- a. Alteration/Addition
 - **i.** Billy Wood Appliance, DRB-001911-2022 Proposed changes to the building façade, color, and landscape.

FACADE DESIGN FOR: BILLY WOOD APPLIANCE

DESIGN TEAM/DRB COMMENT SHEET The comments below are staff recommendations to the Design Review Board (DRB) and do NOT constitute DRB approval or denial.				
PROJECT NAME: Billy Wood Appliance DRB#: DRB-001911-2022 DATE: 07/27/2022 08/15/2022 (Staff recommendation is unchanged from 07/27) RECOMMENDATION: Approval Approval with Conditions Denial RECOMMENDED CONDITIONS: Denial Denial				
APPLICATION MATERIAL				
DRB REQUIREMENTS	Complies Yes	No	Not Applicable	Comments or Conditions
Detail Illustrating Connection to Existing Structure				Based on the illustrations and the drawings it appears the caves of the existing dormer will extend beyond the left and right of the main entry portico. It would be helpful to have an indication of the existing roof overhang on the drawings.

Landscaping Plan

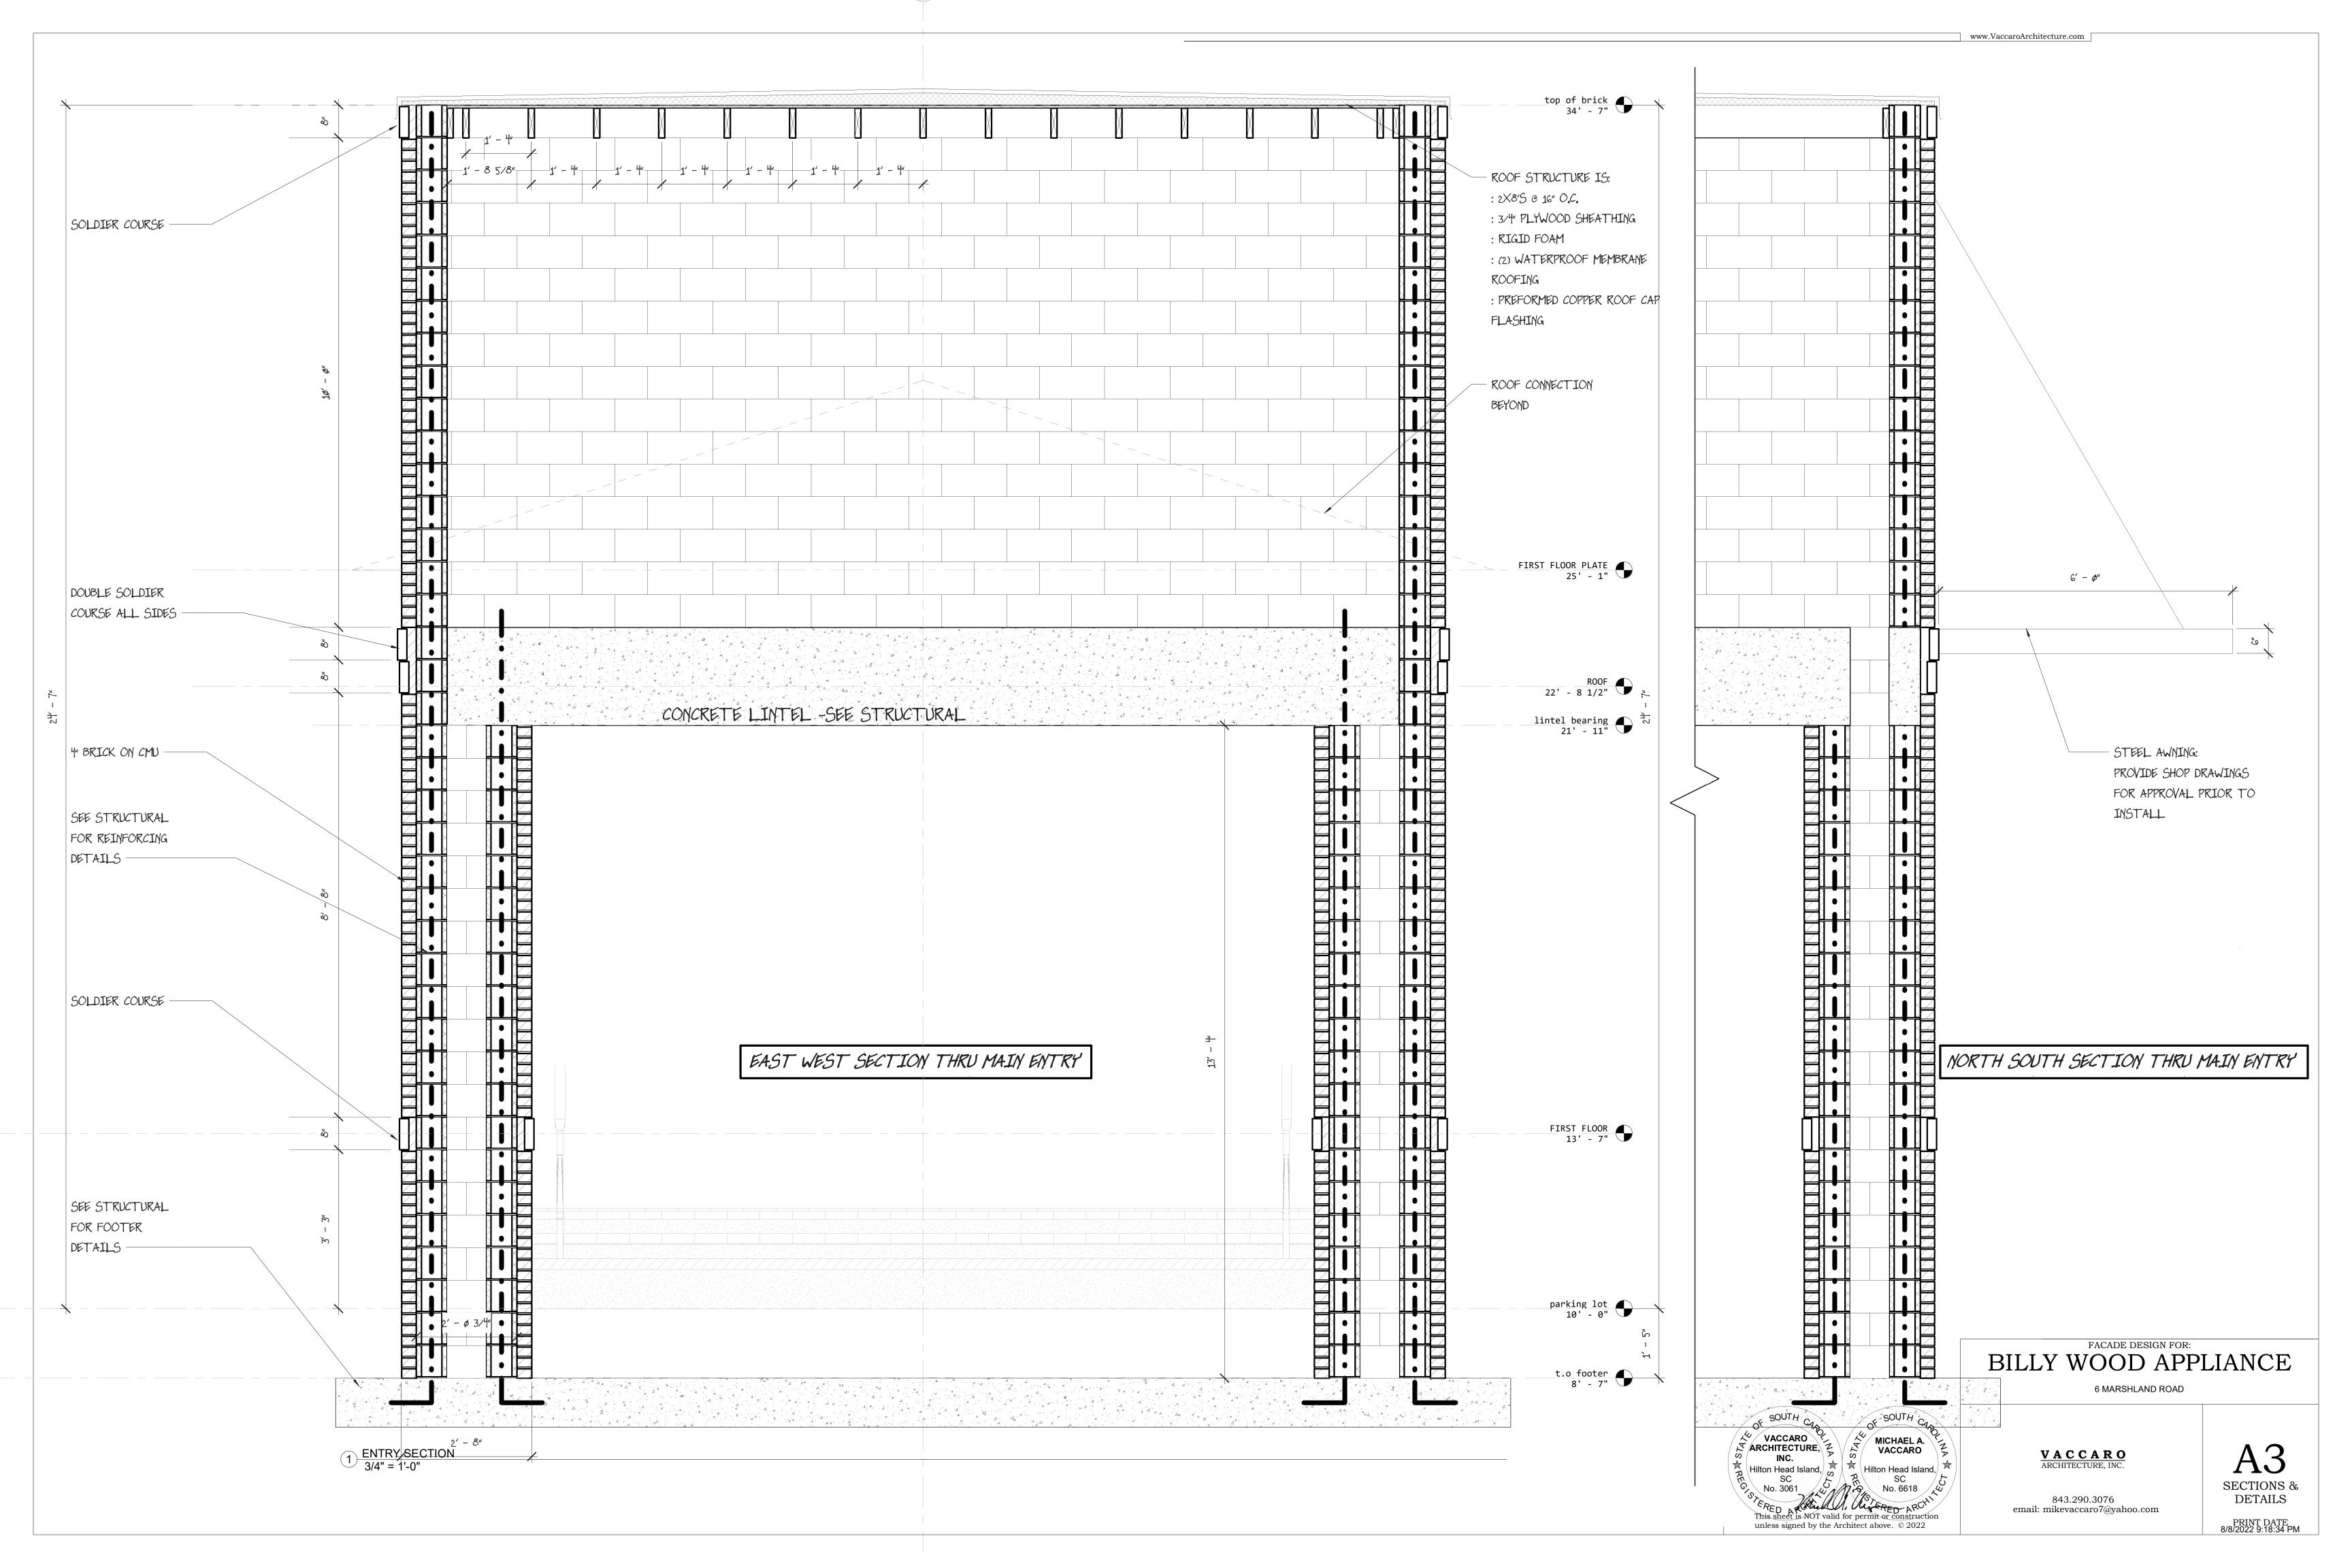
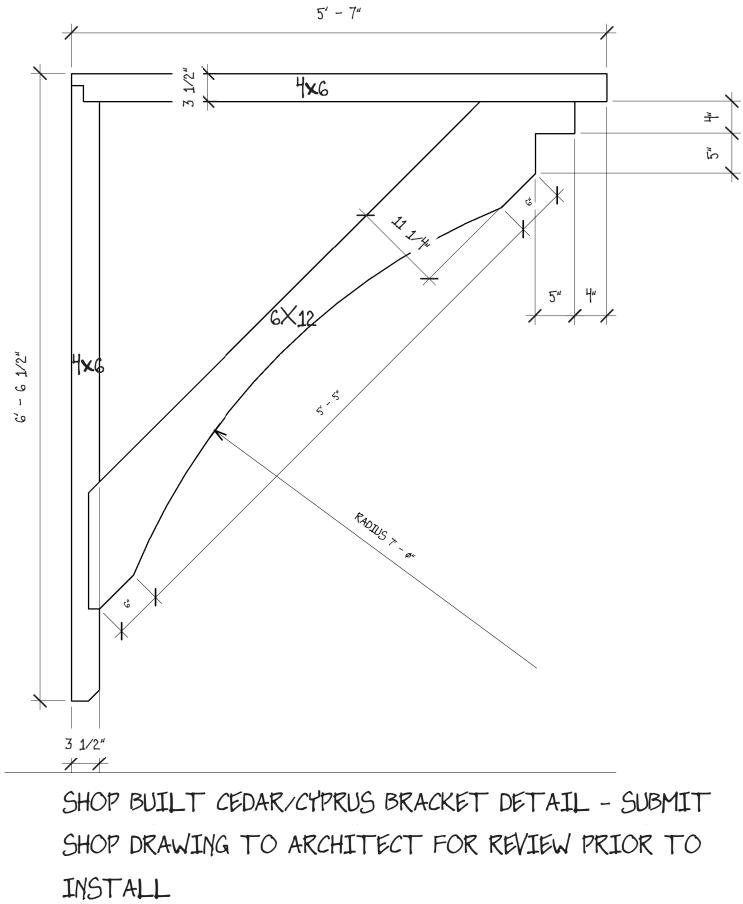
LANDSCAPE DESIGN					
DESIGN GUIDE/LMO CRITERIA	Complies Yes	No	Not Applicable	Comments or Conditions	
Landscape is designed so that it may be maintained in its natural shape and size				 Staff is concerned about the long-term viability of the Inkberry in the front planter. Consider a plant that may be better adapted to those conditions. Staff is not sure how the Yellow Jasmine will perform as a groundcover and suggest consideration of a different species. Staff is concerned about the long-term viability of the Wild Ginger and Lizards Tail. While native to our island, consider plants that may be better adapted to these conditions and maintenance practices. 	
Provides for a harmonious setting for the site's structures, parking areas or other construction				 The preference is to provide vegetation between the parking lot and building. The "Experimental Garden" presents a concern about the long term viability of the planted pots. Understanding there may be issues with surface roots under the birch, Staff suggest an organic mulch and evergreen groundcover.

COLUMN AND FENCE DETAIL 3/4"

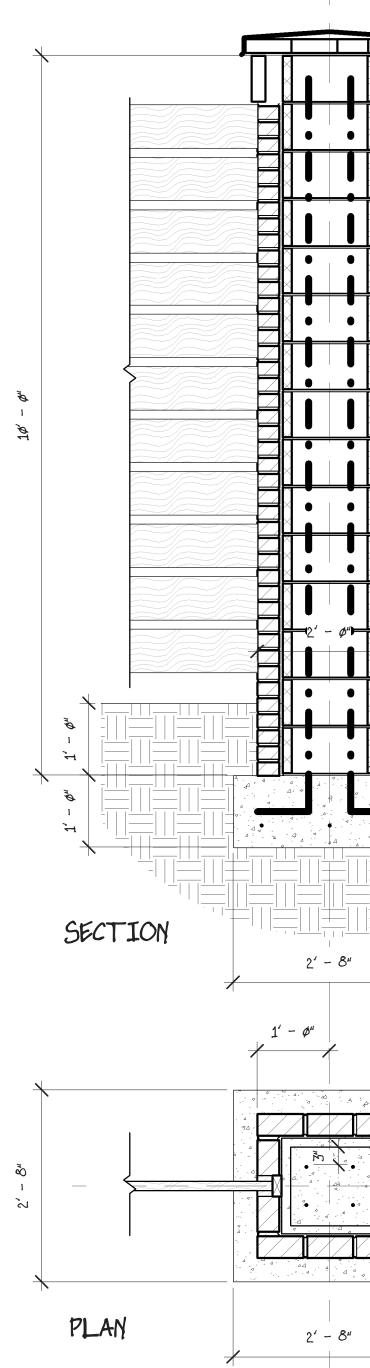
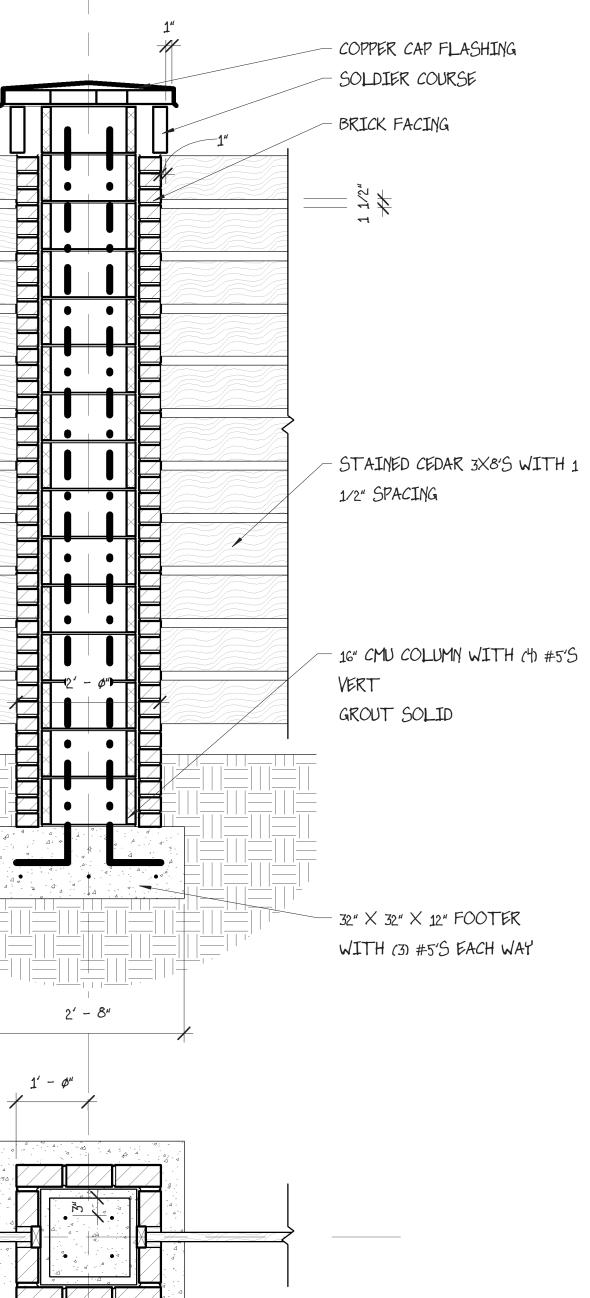
the proposed brick.
Human scale is achieved by the use of proper proportions and architectural elements	\square	The brackets on the right side seem too large for the scale of the building.
